SPECIAL AIRWORTHINESS INFORMATION BULLETIN

CE-05-88
September 30, 2005

Service Bulletin SB 2X-32-10 R1

Service Bulletin SB 2X-32-11

Figure 01 - Nose Gear Strut Inspection

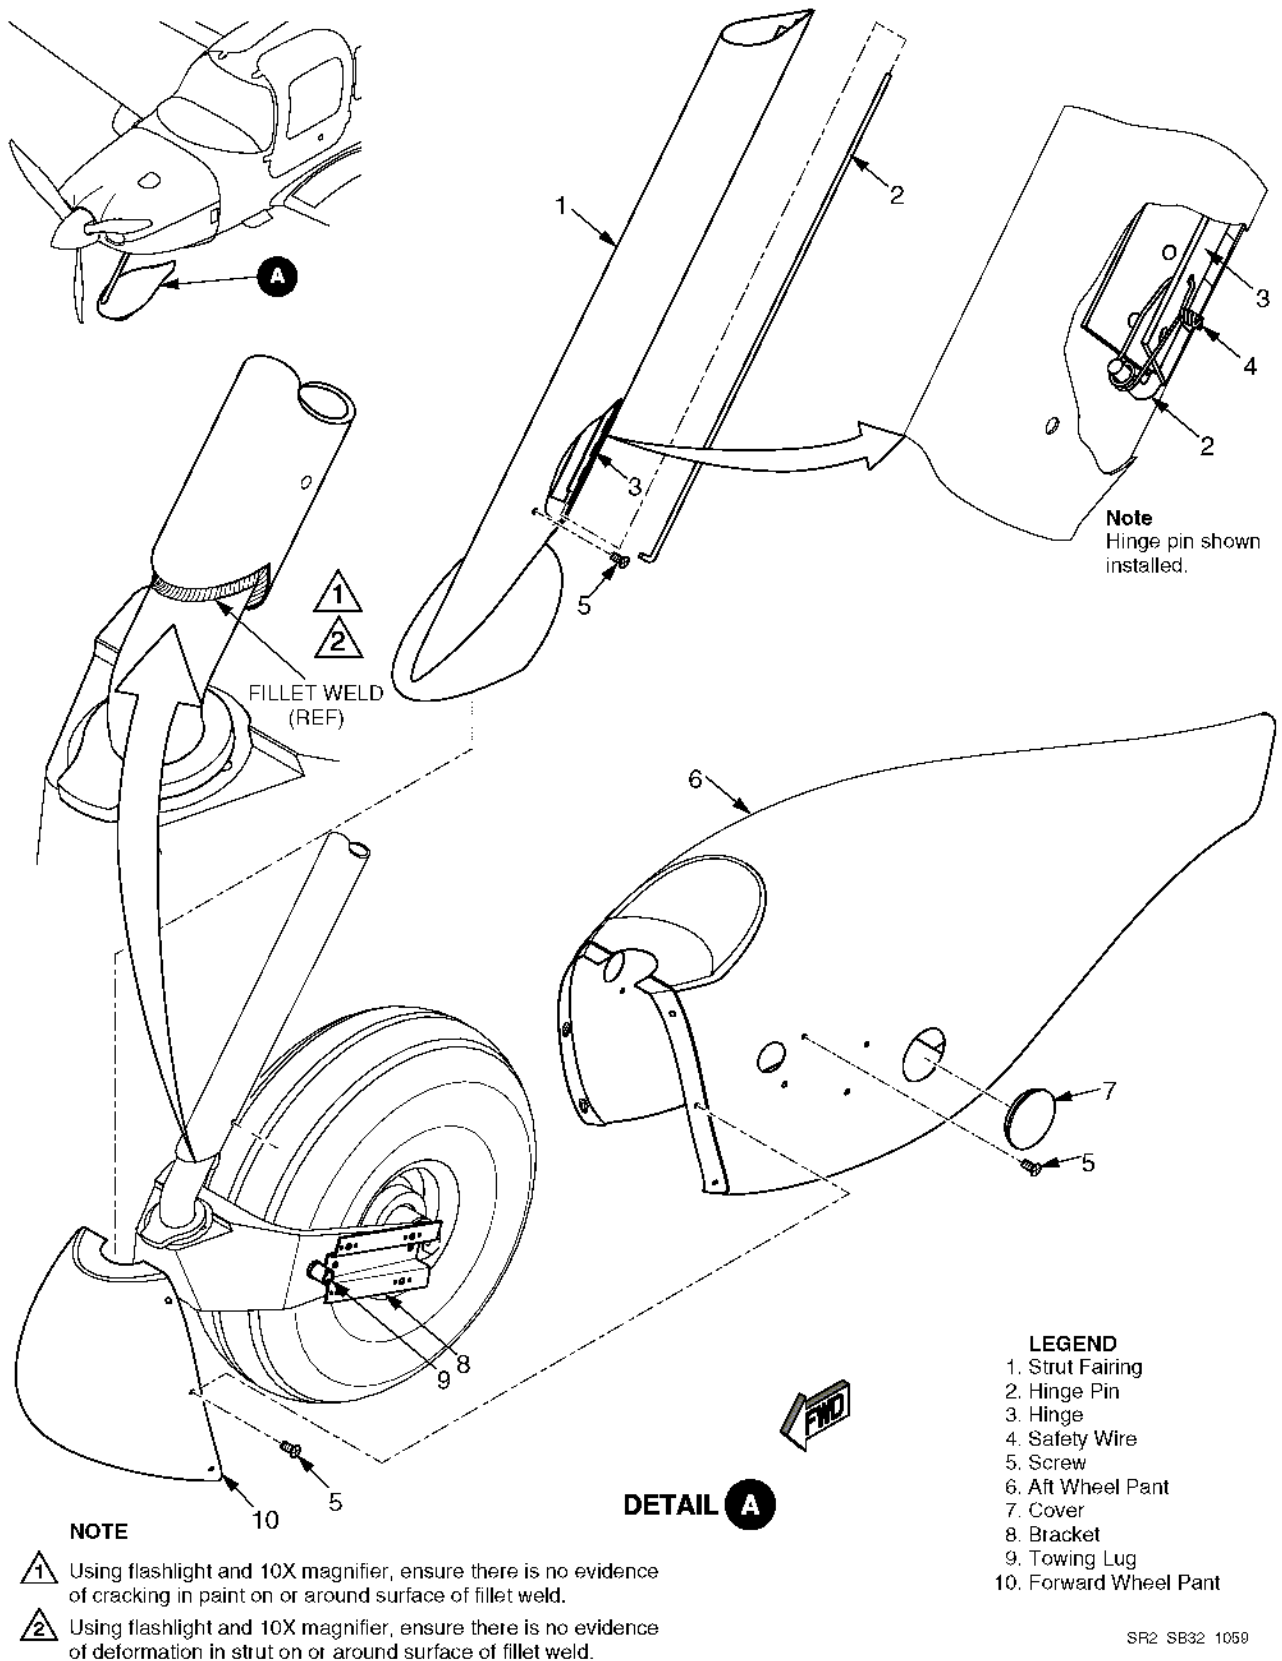
- A. Remove key from ignition.
- B. Ensure BATTERY and AVIONICS master switches are in OFF position.
- C. Remove nose gear fairing. (See Figure 01)
 1. Turn nose wheel to full 108 degree deflection.
 2. Cut and remove safety wire securing hinge pin to strut fairing and pull hinge pin from strut fairing.
 3. Remove screws securing strut fairing to nose gear strut and remove strut fairing from airplane.

CAUTION: If there is any evidence of cracking or deformation in the area around the fillet weld the nose gear strut assembly must be replaced immediately.

- D. Visually inspect the fillet weld between the nose gear strut and wheel spindle in accordance with FAA AC 43.13-1B, Chapter 5, Section 2, Visual Inspection.
 1. Acquire necessary tools, equipment, and supplies.

2. Using flashlight and 10X magnifier, visually inspect fillet weld for signs of distress.
 - a. Verify there is no evidence of cracking in paint on or around surface of fillet weld.

- b. Verify there is no evidence of deformation in nose gear strut on or around surface of fillet weld.
- E. If no cracking or deformation is evident, the nose gear strut replacement can be deferred up to the next annual inspection. Perform the following steps:

Figure 02 - Nose Gear Strut Installation

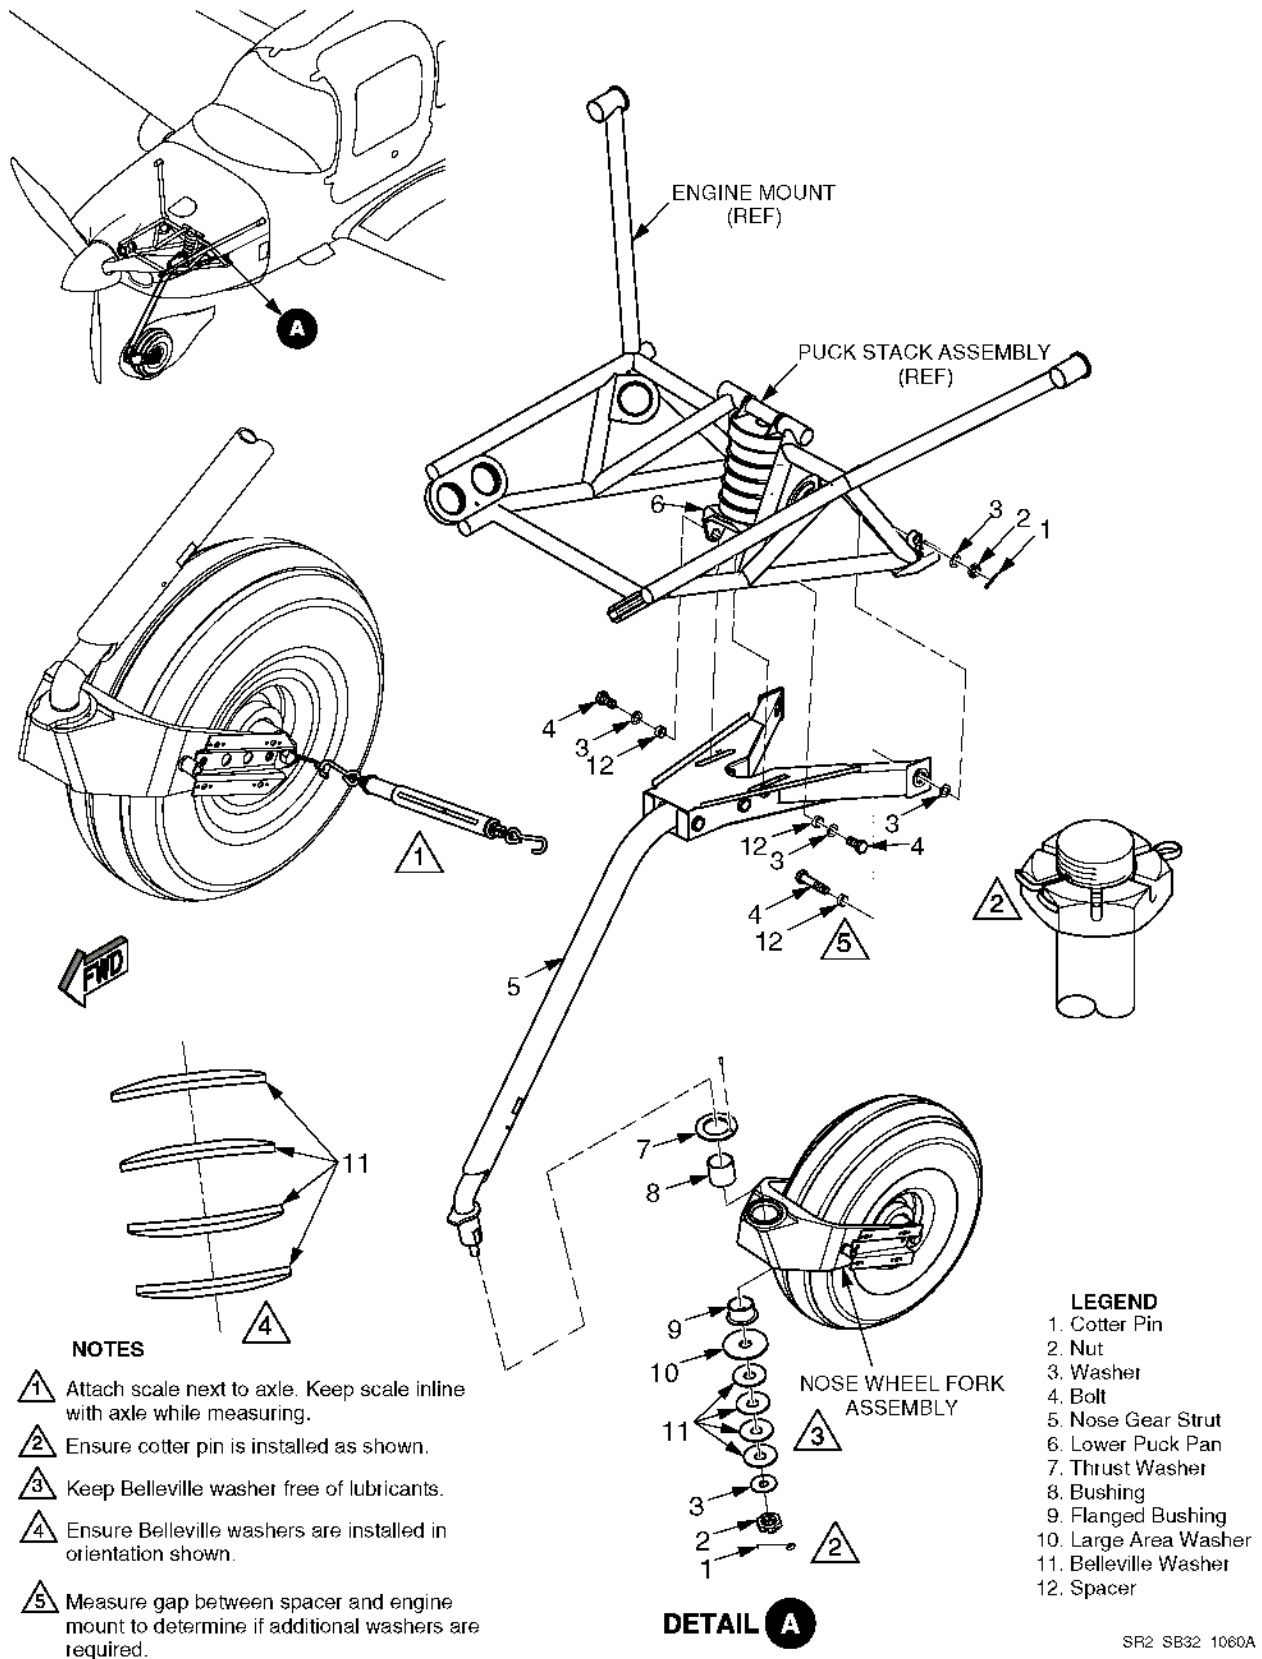
2. Raise airplane on jacks. (Refer to AMM 7-10)
 3. Remove nose wheel fork assembly. (See Figure 02)
 - a. While supporting fork assembly, remove cotter pin, nut, flat washers, and Belleville washers from spindle bolt.

- b. Remove fork assembly from nose gear strut.
 4. Remove existing nose gear strut. (See Figure 02)
 - a. With nose gear strut supported, remove bolts, washers, and spacers securing nose gear strut to lower puck pan.

5. Install new nose gear strut. (See Figure 02)
 - a. Acquire necessary tools, equipment, and supplies.

- b. With nose gear strut supported under airplane, lift strut up until bolt holes are in proper alignment with engine mount.
- c. Apply a thin coat of grease to new bolt shafts (NAS6608-10D) and spacers (13705-003).
- d. Install new bolts (NAS6608-10D), spacers (13705-003), washer (NAS1149F1032P), washer (NAS1149F0863P), and nuts (AN320-8) securing nose gear strut to lower engine mount attach fittings.
- e. At RH and LH lower engine mount attach fittings, measure gap between spacer and engine mount. Add RH and LH gap values together to obtain total gap. Reference total gap in the following table to determine if additional washers (NAS1149F1032P) are required.

Total Gap	Number of Additional Washers
Less than 0.125 (3.2 mm)	None.
0.125 - 0.250 (3.2 - 6.4 mm)	1 each side.
0.250 and 0.375 inch (6.4 and 9.5 mm)	2 each side.
Greater than 0.375 inch (9.5 mm)	Contact Cirrus Design for disposition.

- f. Torque nuts to 480 - 690 in-lb (53 - 76 Nm) and install new cotter pins (MS24665-285).
 - g. Install new bolts (NAS6608H5), washers (NAS1149F0863P), and spacers (13705-004) securing nose gear strut to lower puck pan. Torque bolts to 480 - 690 in-lb (53 - 76 Nm). Safety wire bolts to nose gear strut.
6. Install nose wheel fork assembly. (See Figure 02)
 - a. Acquire necessary tools, equipment, and supplies.

- d. Install new washer (AN970-8), Belleville washers (50750-101), and washer (NAS1149F0863P) in correct orientation.
- e. Secure nose wheel fork assembly with new castellated spindle nut (MS17826-8).
- f. Attach spring scale to axle on nose wheel fork assembly and torque castellated spindle nut so a constant force of more than 49 lbs (22.2 kg) is required to rotate nose wheel fork and wheel assembly.
- g. Loosen castellated spindle nut.
- h. Attach spring scale to axle on nose wheel fork assembly and torque castellated spindle nut so a constant force of 20 - 25 lbs (9.1 - 11.3 kg) is required to rotate nose wheel fork and wheel assembly.
- i. After re-torquing castellated spindle nut, secure nut with new cotter pin (MS24665-355). Bend cotter around castellated spindle nut as shown. (See Figure 02)

Figure 01 - Nose Gear Strut Inspection

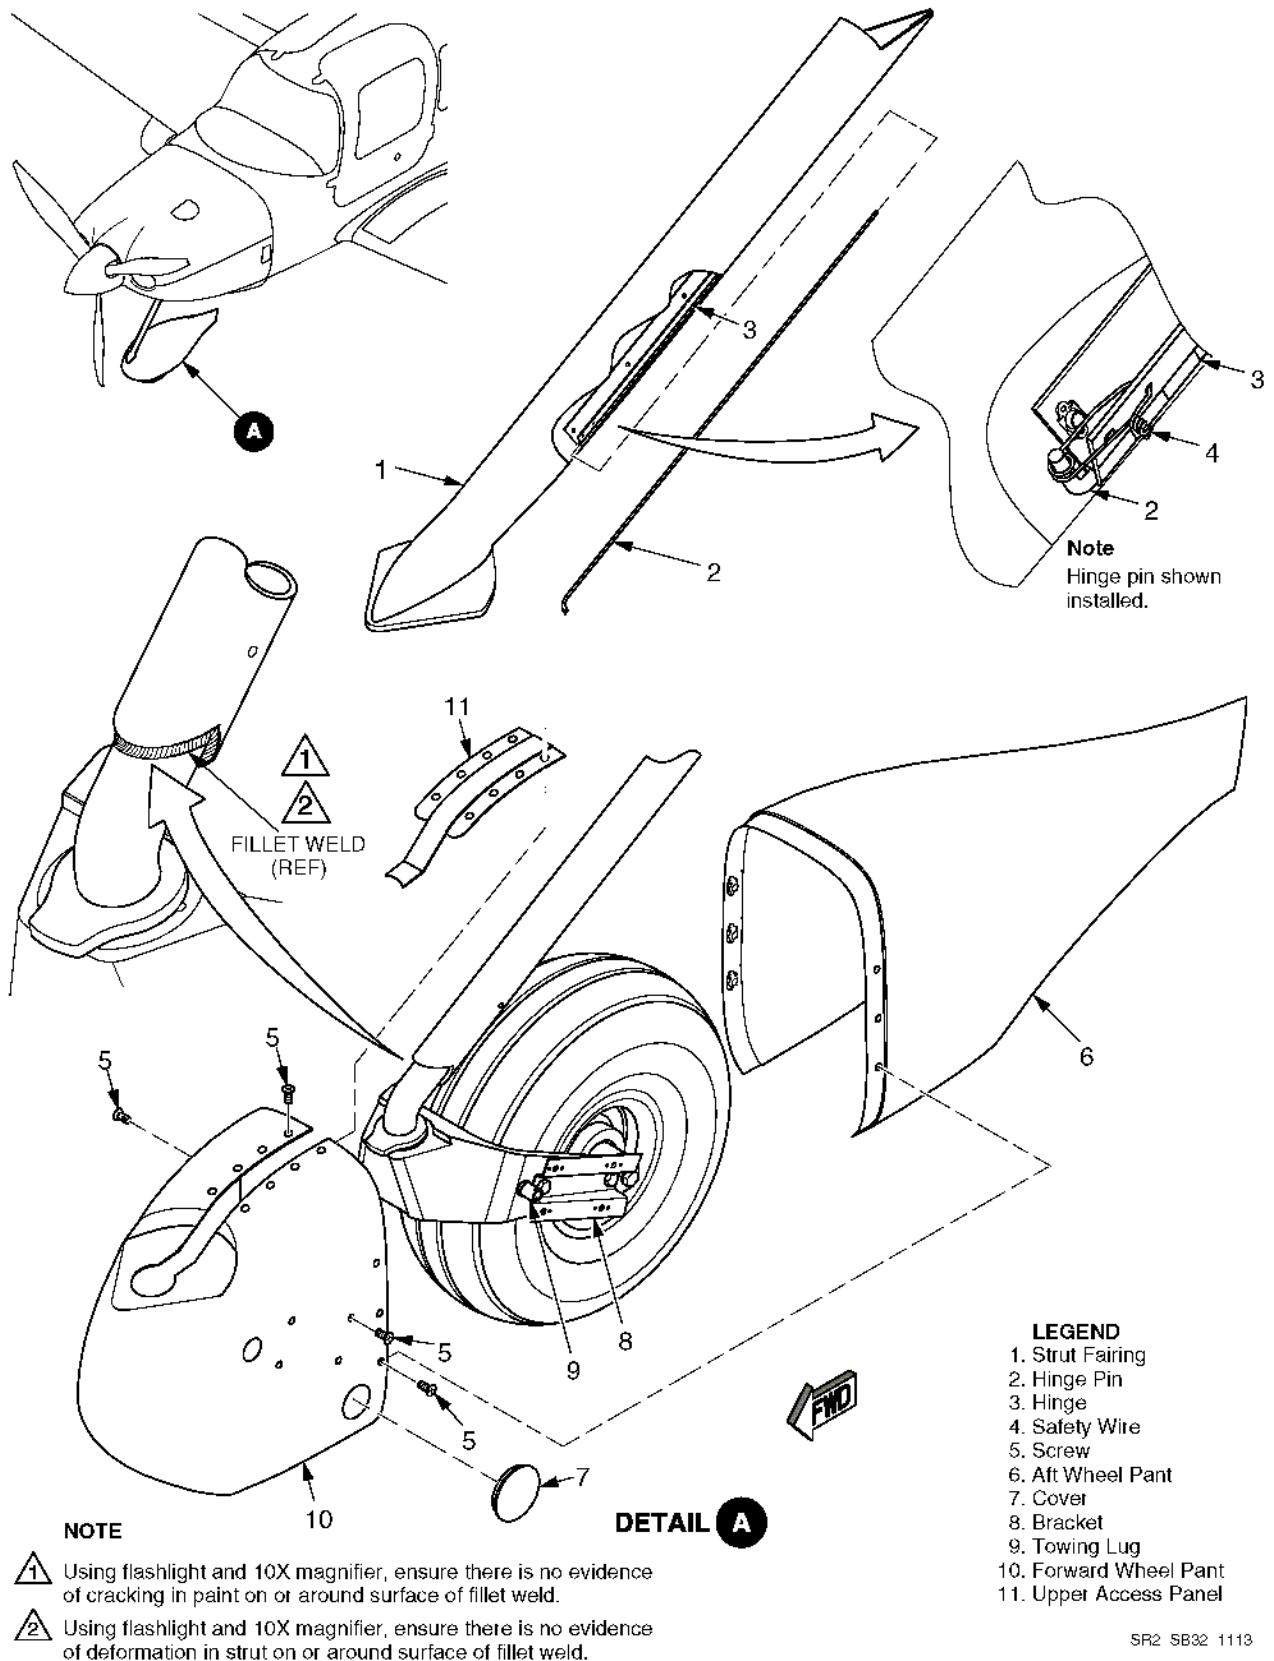
CAUTION: If there is any evidence of cracking or deformation in the area around the fillet weld the nose gear strut assembly must be replaced immediately.

- E. Visually inspect the fillet weld between the nose gear strut and wheel spindle in accordance with FAA AC 43.13-1B, Chapter 5, Section 2, Visual Inspection.

2. Using flashlight and 10X magnifier, visually inspect fillet weld for signs of distress.
 - a. Verify there is no evidence of cracking in paint on or around surface of fillet weld.

- b. Verify there is no evidence of deformation in nose gear strut on or around surface of fillet weld.
- F. If no cracking or deformation is evident, the nose gear strut replacement can be deferred up to the next annual inspection. Perform the following steps:

Figure 02 - Nose Gear Strut Installation

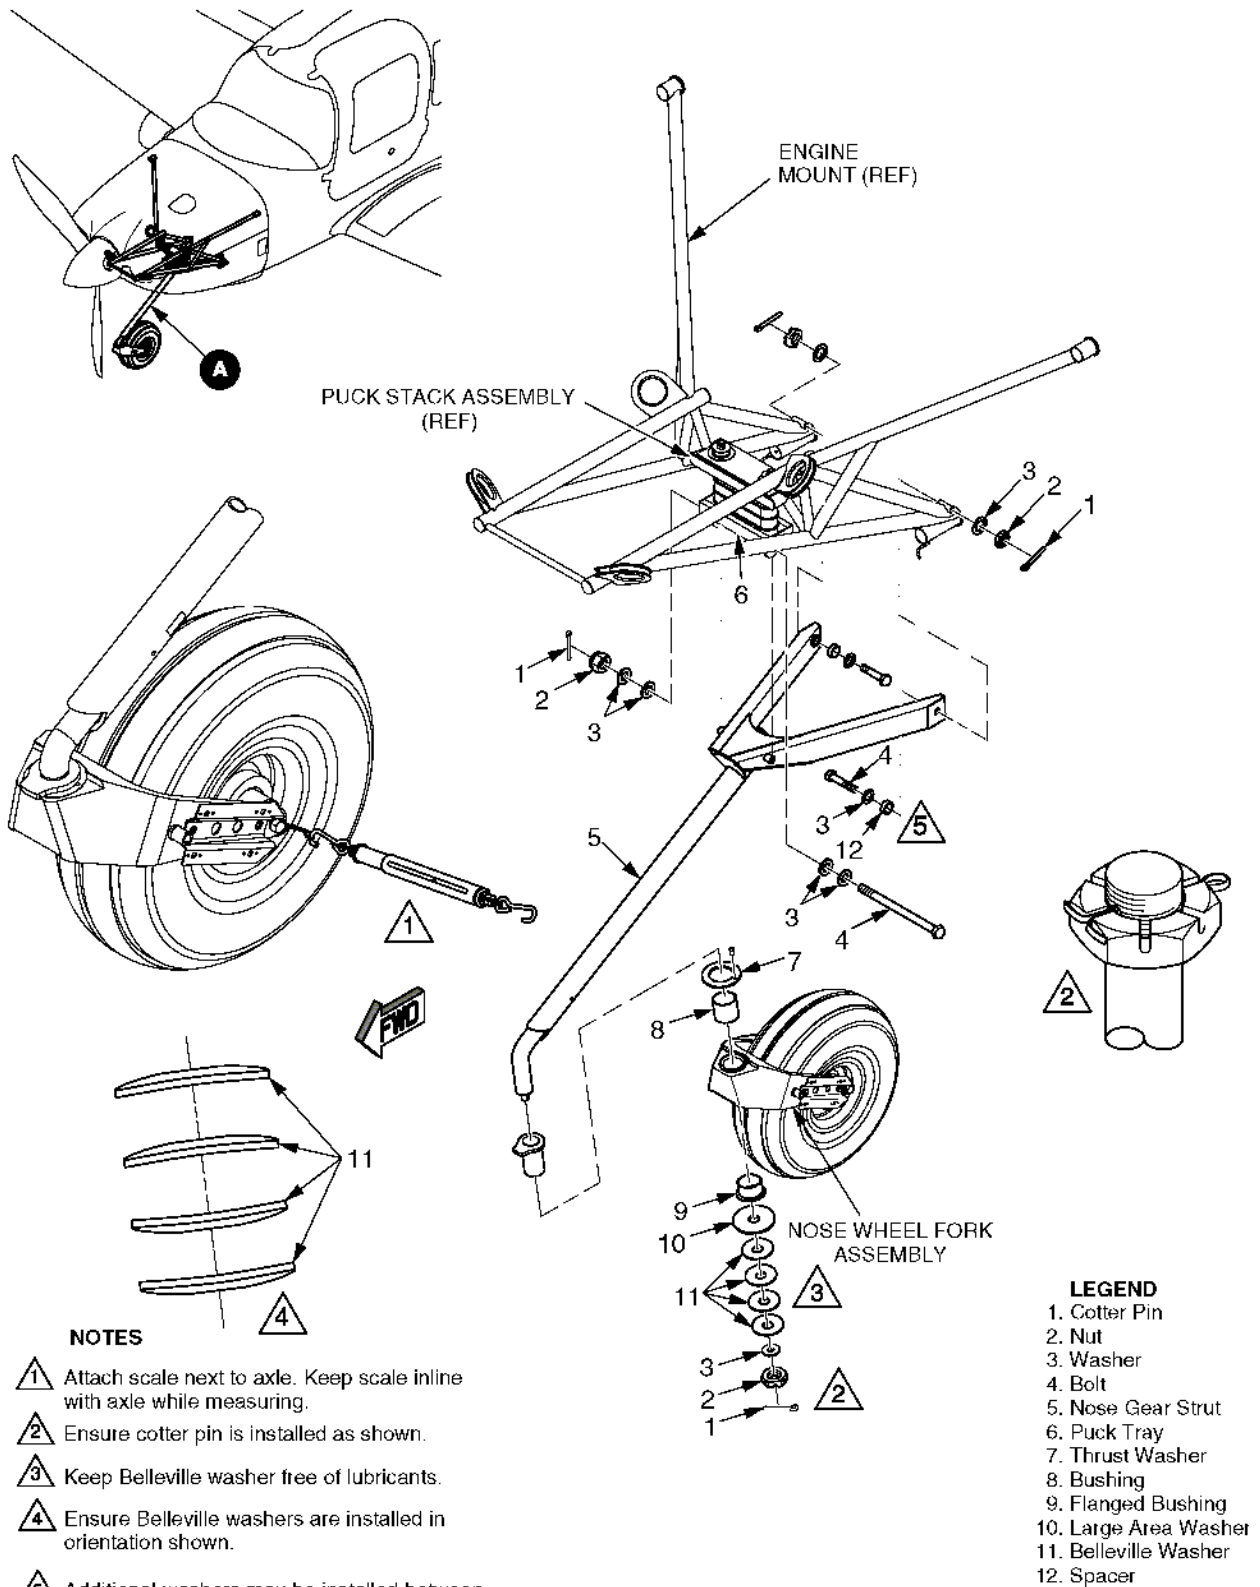
Note: Additional washers may be installed between nose gear strut and engine mount as required to eliminate any gap. Two washers per side maximum.

- d. Install new bolts (NAS6206-26D), spacers (12935-001), washers (NAS1149F0632P), and nuts (AN320-6) securing nose gear strut to lower engine mount. Torque nuts to 80 - 95 in-lb (9.0 - 10.7 Nm) and install new cotter pins (MS24665-283).
 - e. Apply a thin coat of grease to new bolt shaft (AN6-64).
 - f. Install new bolt (AN6-64), washers (NAS1149F0663P), and nut (AN310-6) securing nose gear strut to lower puck pan. Torque bolt to 80 - 95 in-lb (9.0 - 10.7 Nm) and install new cotter pin (MS24665-283).
6. Install nose wheel fork assembly.
- a. Acquire necessary tools, equipment, and supplies.

- d. Install new washer (AN970-8), Belleville washers (50750-101), and washer (NAS1149F0863P) in correct orientation.
- e. Secure nose wheel fork assembly with new castellated spindle nut (MS17826-8).
- f. Attach spring scale to axle on nose wheel fork assembly and torque castellated spindle nut so a constant force of more than 49 lbs (22.2 kg) is required to rotate nose wheel fork and wheel assembly.
- g. Loosen castellated spindle nut.
- h. Attach spring scale to axle on nose wheel fork assembly and torque castellated spindle nut so a constant force of 20 - 25 lbs (9.1 - 11.3 kg) is required to rotate nose wheel fork and wheel assembly.
- i. After re-torquing castellated spindle nut, secure nut with new cotter pin (MS24665-353). Bend cotter around castellated spindle nut as shown. (See Figure 02)
